Agenda Item # 5

SUB-003689-2026

The Villas at Cody Crossing Subdivision

THE VILLAS AT CODY CROSSING SUBDIVISION

DETAIL SITE PLAN

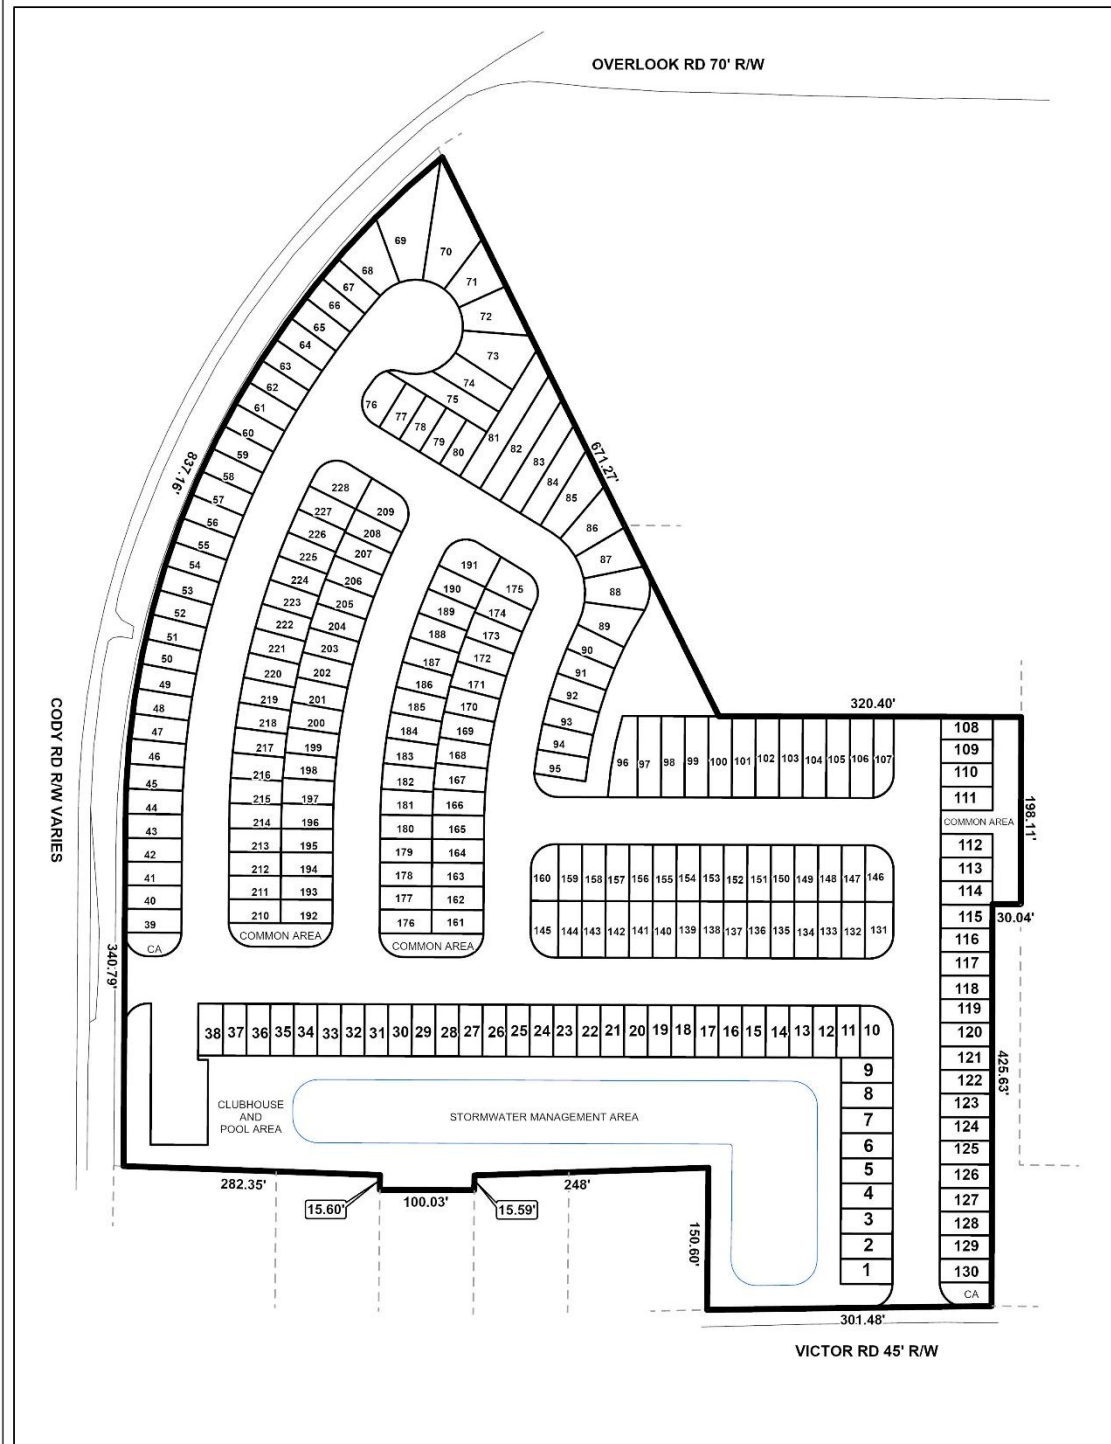
- B. Label each proposed PRIVATE ROW with the approved street name, ROW width, and "PRIVATE".
- C. Show and label the property line along Cody Road. There is a dashed line and a solid line but neither is labeled.

- D. If there is any dedication of property to public ROW it needs to be shown, labeled, and include the proposed area (sf and acre) of dedication.
- E. Provide a vicinity map.

The site has frontage along Cody Road North and Victor Road. Cody Road North is a Major Collector street without curb and gutter requiring a 100-foot-wide right-of-way, and Victor Road is a minor street with a ribbon curb and gutter requiring a 50-foot-wide right-of-way. The preliminary plat depicts a varying right-of-way along Cody Road North and a substandard, 45-foot-wide right-of-way along Victor Road. As mentioned, Cody Road North requires a 100-foot right-of-way. Furthermore, rezoning of the property to R-3 required dedication sufficient to provide 50-feet from the centerline of Cody Road. As such, if approved, the plat should be revised to depict compliance with this requirement. Regarding Victor Road, if approved, the plat should be revised to illustrate dedication sufficient to provide 25-feet from its centerline.

Several new private streets are proposed, and each is depicted with a 50-foot-wide right-of-way, which is compatible with Section 6.B.9. of the Subdivision Regulations for streets equipped with curb and gutter. As the streets will be private, a note should be required on the revised plat, if approved, stating that the streets are privately maintained and that there shall be no public right-of-way, per Sections 9.D.1(b)(5) and 9.D.1(b)(7) of the Subdivision Regulations. Another note should be required on the revised plat, if approved, stating that if the private streets are ultimately dedicated for public use and maintenance, 100-percent of the cost of the improvements required to bring the streets up to the prevailing standards shall be assessed to the property owner(s) at the time the private streets are dedicated, and that said assessment shall run with the land to any subsequent property owners, per Section 9.D.1(b)(9) of the Subdivision Regulations.

The names of the proposed streets are not provided on the preliminary plat and should be coordinated with the Engineering Department to avoid any duplicate street names within Mobile City limits. If approved, street names should be provided on the Final Plat.

Per Section 6.C.7. of the Subdivision Regulations, double frontage lots, such as the proposed Lots 39-69 should be limited to one (1) street for access. As such, if approved, a waiver of Section 6.C.7. of the Subdivision Regulations

will be required, and a note should be placed on the Final Plat stating that Lots 39-69 are denied direct access to Cody Road North.

The currently proposed lot sizes are as small as 1,250 square feet, with an average size of 1,375 square feet. The previously approved Variance allowed lot sizes ranging from 1,367 square feet to 2,179 square feet. Per Article 2, Section 64-2-7.E.1. of the UDC, the minimum lot size for lots in the R-3 Suburban district is 10,000 square feet. As such, a waiver of Section 6.C.2.(a) of the Subdivision Regulations is required for approval of the request.

None of the lots meet the minimum 60-foot width requirement of Section 6.C.2(b)(2) of the Subdivision Regulations for residential lots located within the suburban sub-district. As such, a waiver of Section 6.C.2(b)(2) of the Subdivision Regulations will be required for approval of the request.

The preliminary plat depicts several proposed common areas. No information regarding each of their sizes is depicted, as required by Section 5.A.2(f). of the Subdivision Regulations. As such, if approved, each common area should be labeled with its size in both square feet and acres on the Final Plat; or provision of a table on the Final Plat with the same information will suffice. Pursuant to Section 2.A. of the Subdivision Regulations, a note should be placed on the Final Plat, if approved, stating that maintenance of all common area is the responsibility of the property owner(s) and not the City of Mobile.

A 10-foot front yard setback is requested on each proposed lot, which is incompatible with the minimum 25-foot front yard setback requirement of Article 2, Section 64-2-7.E.6. of the UDC for lots in the R-3 Suburban district. As such, if approved, the Final Plat should be revised to illustrate a 25-foot front yard setback along each street frontage, unless a Variance allowing reduced setbacks is approved by the Board of Zoning Adjustment.

1. Dedication to provide 50-feet from the from the centerline of Cody Road;
2. Dedication to provide 25-feet from the from the centerline of Victor Road;

3. Approval of the proposed street names by the City Engineer, with any streets labeled on the Final Plat;
4. Provision of signs at the entrances to the private streets with the street names and identifying them as private streets, per Manual on Uniform Traffic Control Devices (MUTCD) standards;

5. Revision of the plat to illustrate the applicable utility easements, per Section 9.D.1(b)(4) of the Subdivision Regulations;
6. Placement of a note on the revised plat stating that the streets are privately maintained and that there shall be no public right-of-way, in compliance with Sections 9.D.1(b)(5) and 9.D.1(b)(7) of the Subdivision Regulations;

9. Placement of a note on the Final Plat stating that Lots 39-69 are denied direct access to Cody Road North;
10. Revision of the plat to label each lot with its size in square feet and acres, adjusted for dedication, or provision of a table on the Final Plat with the same information;

11. Revision of the plat to label each common area with its size in square feet and acres, adjusted for dedication, or provision of a table on the Final Plat with the same information;

13. Revision of the plat to illustrate a 25-foot front yard setback along each proposed street, in compliance with Section 6.C.8. of the Subdivision Regulations, and with Article 2, Section 64-2-6.E. of the Unified Development Code, or acquisition of the necessary variances;

14. Either revision of the plat to depict compliance with lot sizes, setbacks, site coverage, and amount of Common Area, or approval of a Variance for these items;
